FINAL 2019 ULTRASOUND ARRAY CONTROL STUDY (UPDATED)

Stakeholder Comments and Response to Comments

Responses to Stakeholder Comments on the Proposed 2019 Ultrasound Array Control Study

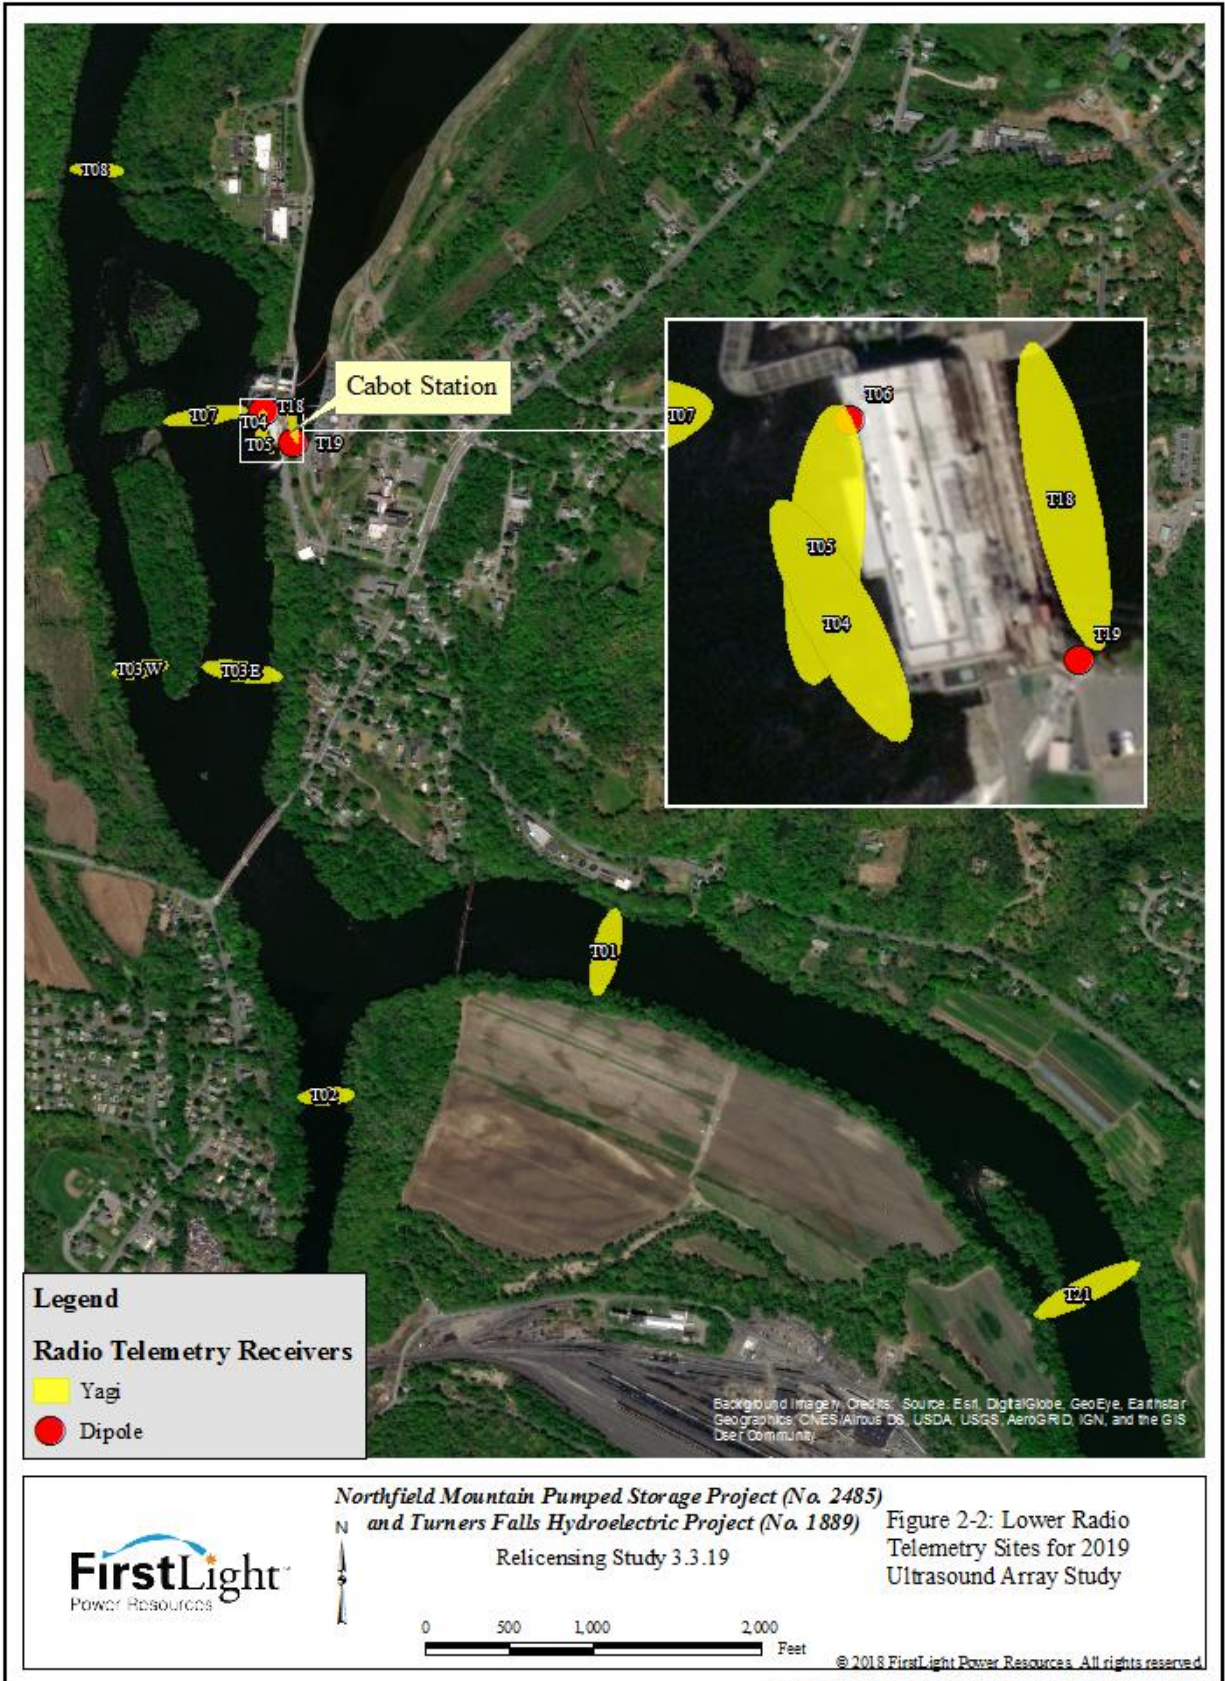
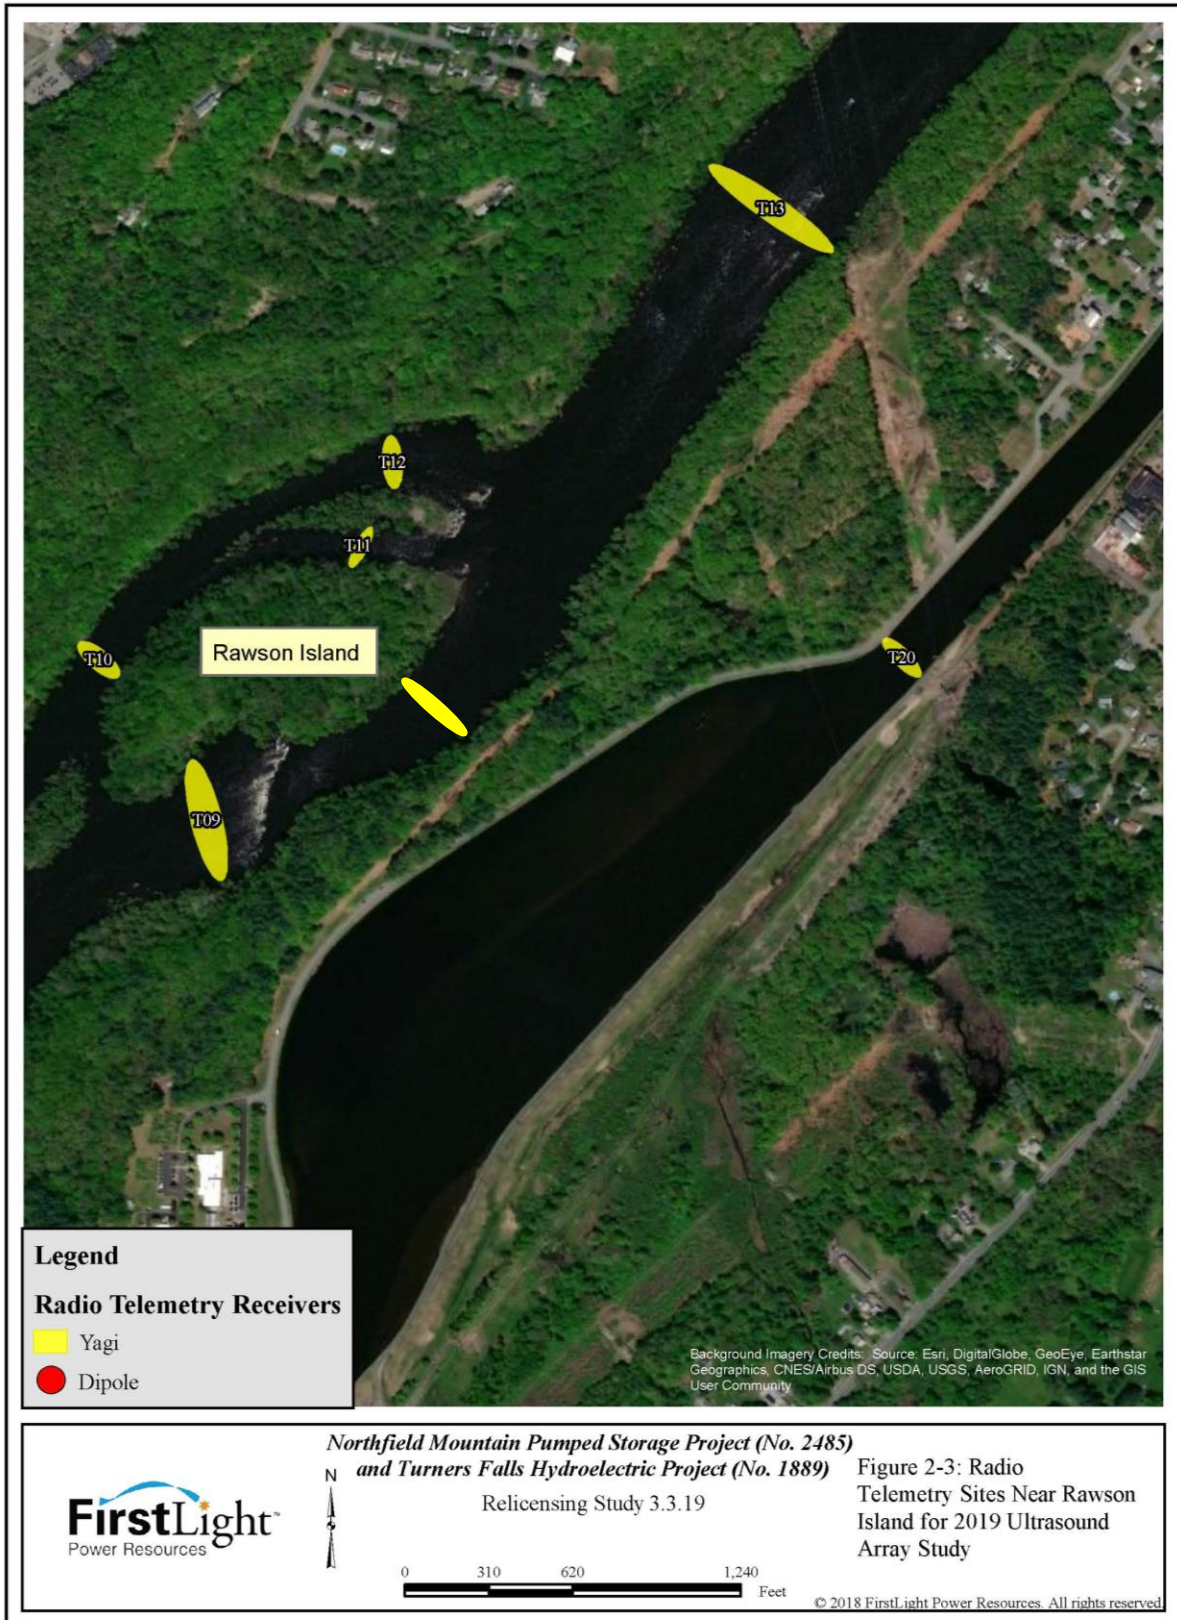
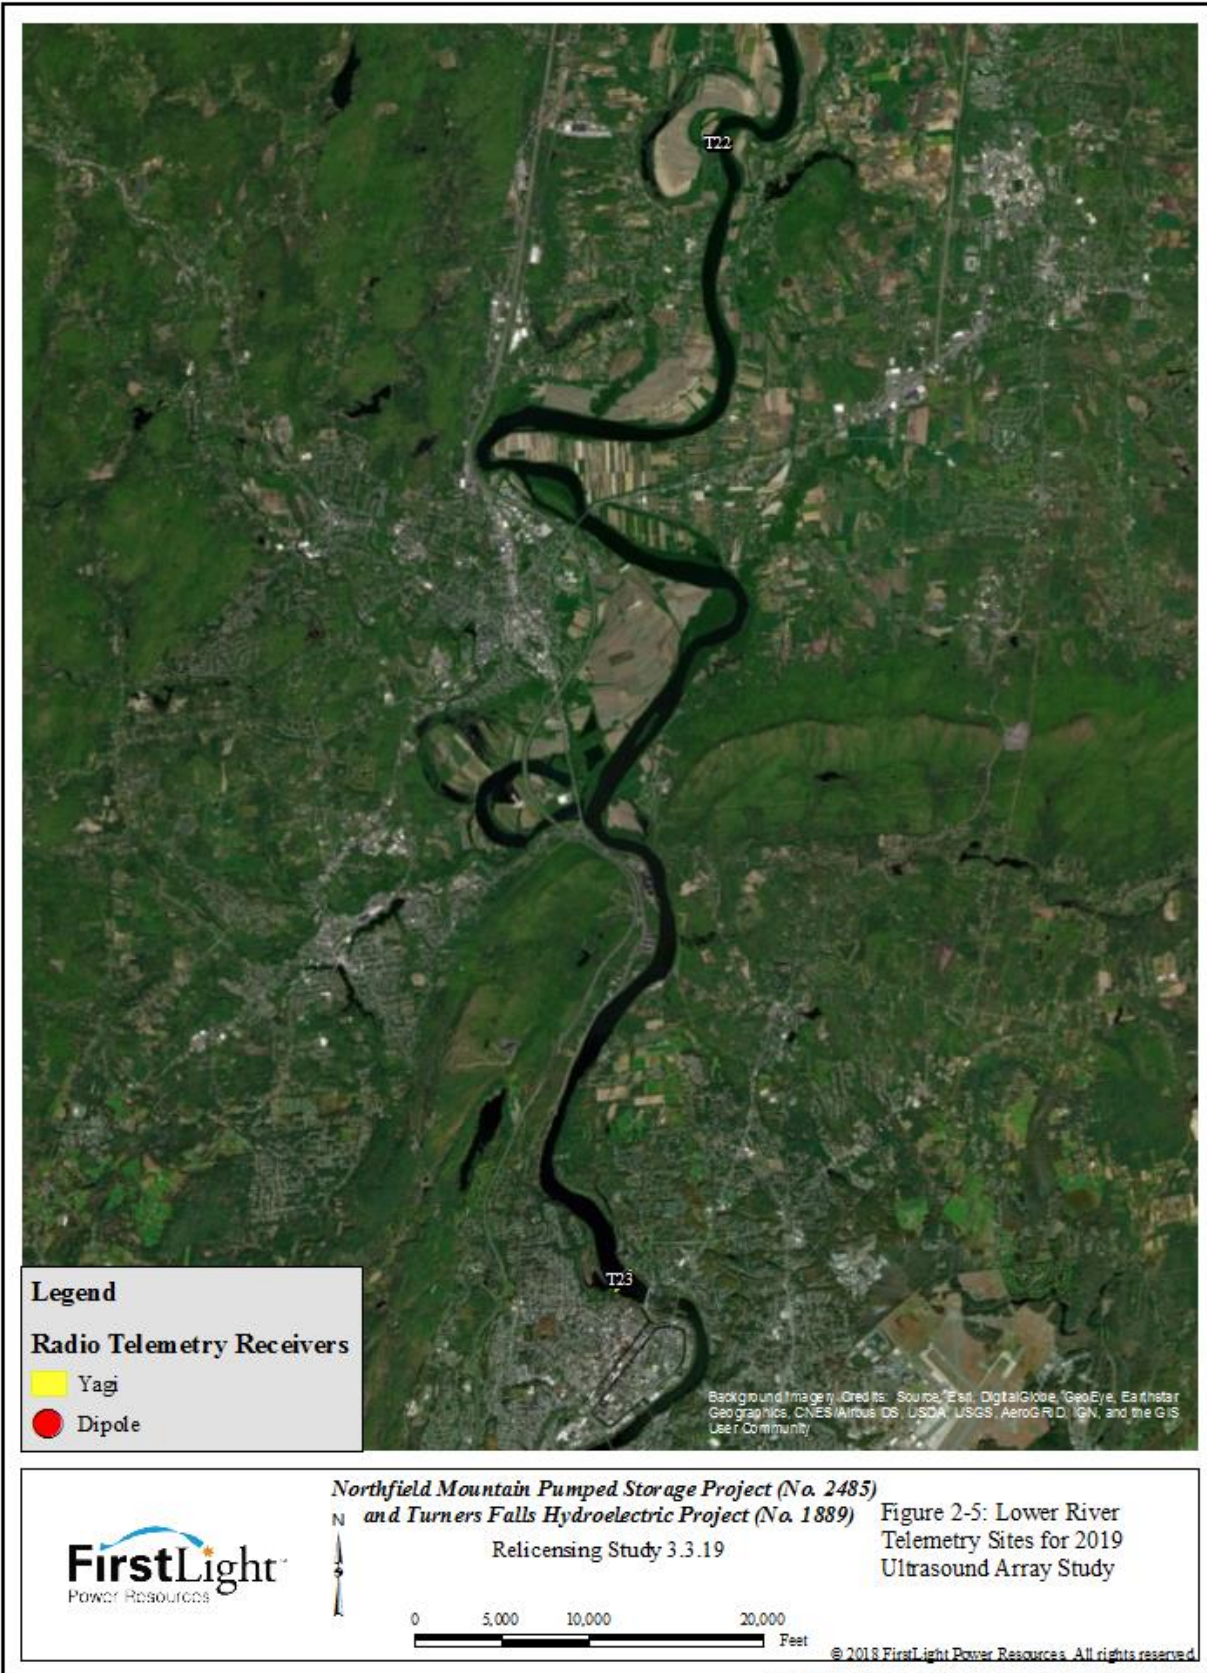
As currently configured, there would be an Orion receiver in the middle channel at Rawson Island. If possible, we recommend installing dipole(s) there instead. This potentially would eliminate some of the likely overlap with fish in the larger channel and at Rock Dam if an aerial antenna is used.

If it is possible to monitor fish in the middle channel at Rawson Island with dipole(s) since it is so narrow, it would seem to eliminate some of the likely overlap with fish in the larger channel and at Rock Dam if a yagi is used.

10		As currently configured, there would be an Orion receiver in the middle channel at Rawson Island. If possible, we recommend installing dipole(s) there instead. This potentially would eliminate some of the likely overlap with fish in the larger channel and at Rock Dam if an aerial antenna is used.	FL will deploy a dropper instead of a Yagi for the middle channel of Rawson Island to address this concern. However, we recommend the use of a Yagi antenna in the wider channel (river right looking downstream). This approach provides a logistically easier setup and the deductive logic to determine which way fish passed (i.e. only those detected by the droppers will be assigned a route in the middle channel). No overlap between the Yagi antenna monitoring the Rock Dam and other locations is envisioned based on the results of the 2015 study effort. We proposed a dipole or dropper antenna at Rock Dam in the study plan but upon further consideration we don't think that is feasible. It should be a Yagi.																																										
11		We support modifying the flow release schedule per Don Pugh's recommendations. In general, the goal should be to lengthen each treatment and reduce the number of transitions between treatments.	FL understands there is concern that not enough 6,500 cfs flow releases would be tested under the proposed flow release schedule in the plan. However, Don Pugh's proposal over-weighs 6,500 cfs treatment during a period that historically suggests the most concentrated migration. We are concerned that such an unbalanced study design would lead to spurious correlation of treatment and response. To address this an alternative flow schedule was included in the updated study plan.																																										
12		We request that separate bypass sluice and Cabot unit survival models be developed.	That is FL's intent																																										
1	Don Pugh (CRC), dated 03/29/2019
